Product Change Notification / RMES-13RZIY008

CCB 4820 Final Notice: Qualification of ATP7 as an additional assembly site for selected Atmel ATXMEGA32E5, ATXMEGA16E5, ATXMEGA8E5 and AT73C507 device families available in 32L UQFN (4x4x0.6mm) package.

PCN #: RMES-13RZIY008

ASE

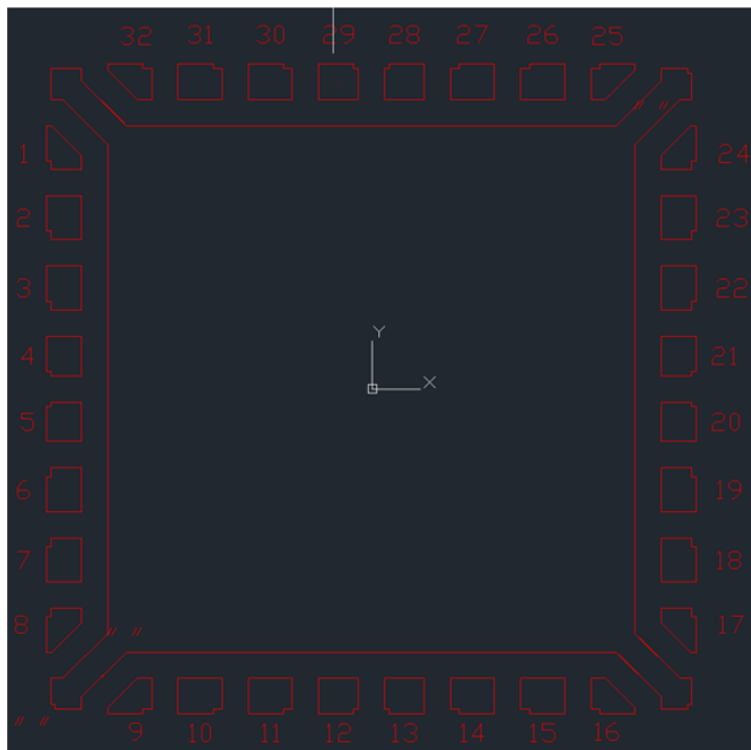
LeadFrame Comparison

Lead frame material

C194

ATP7

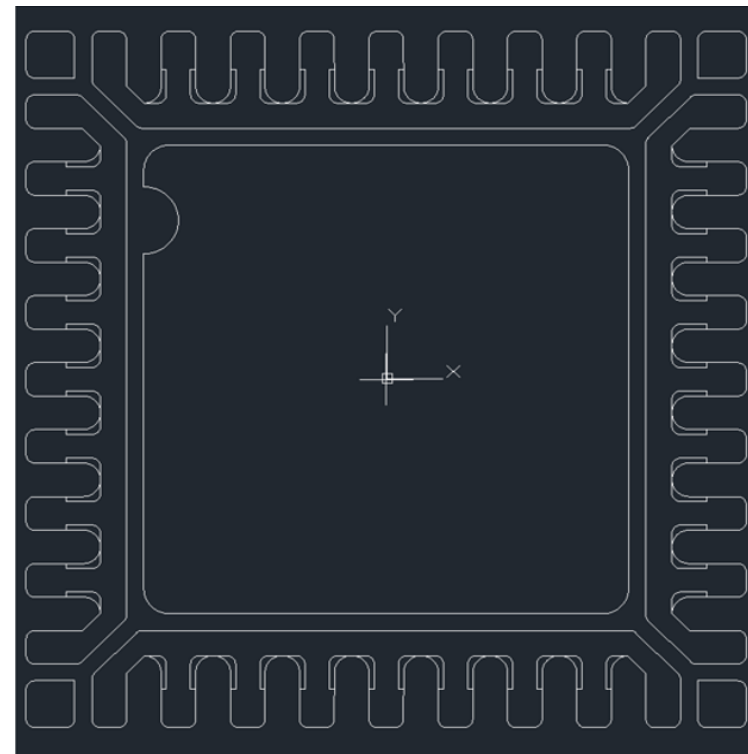
Lead frame material

C194
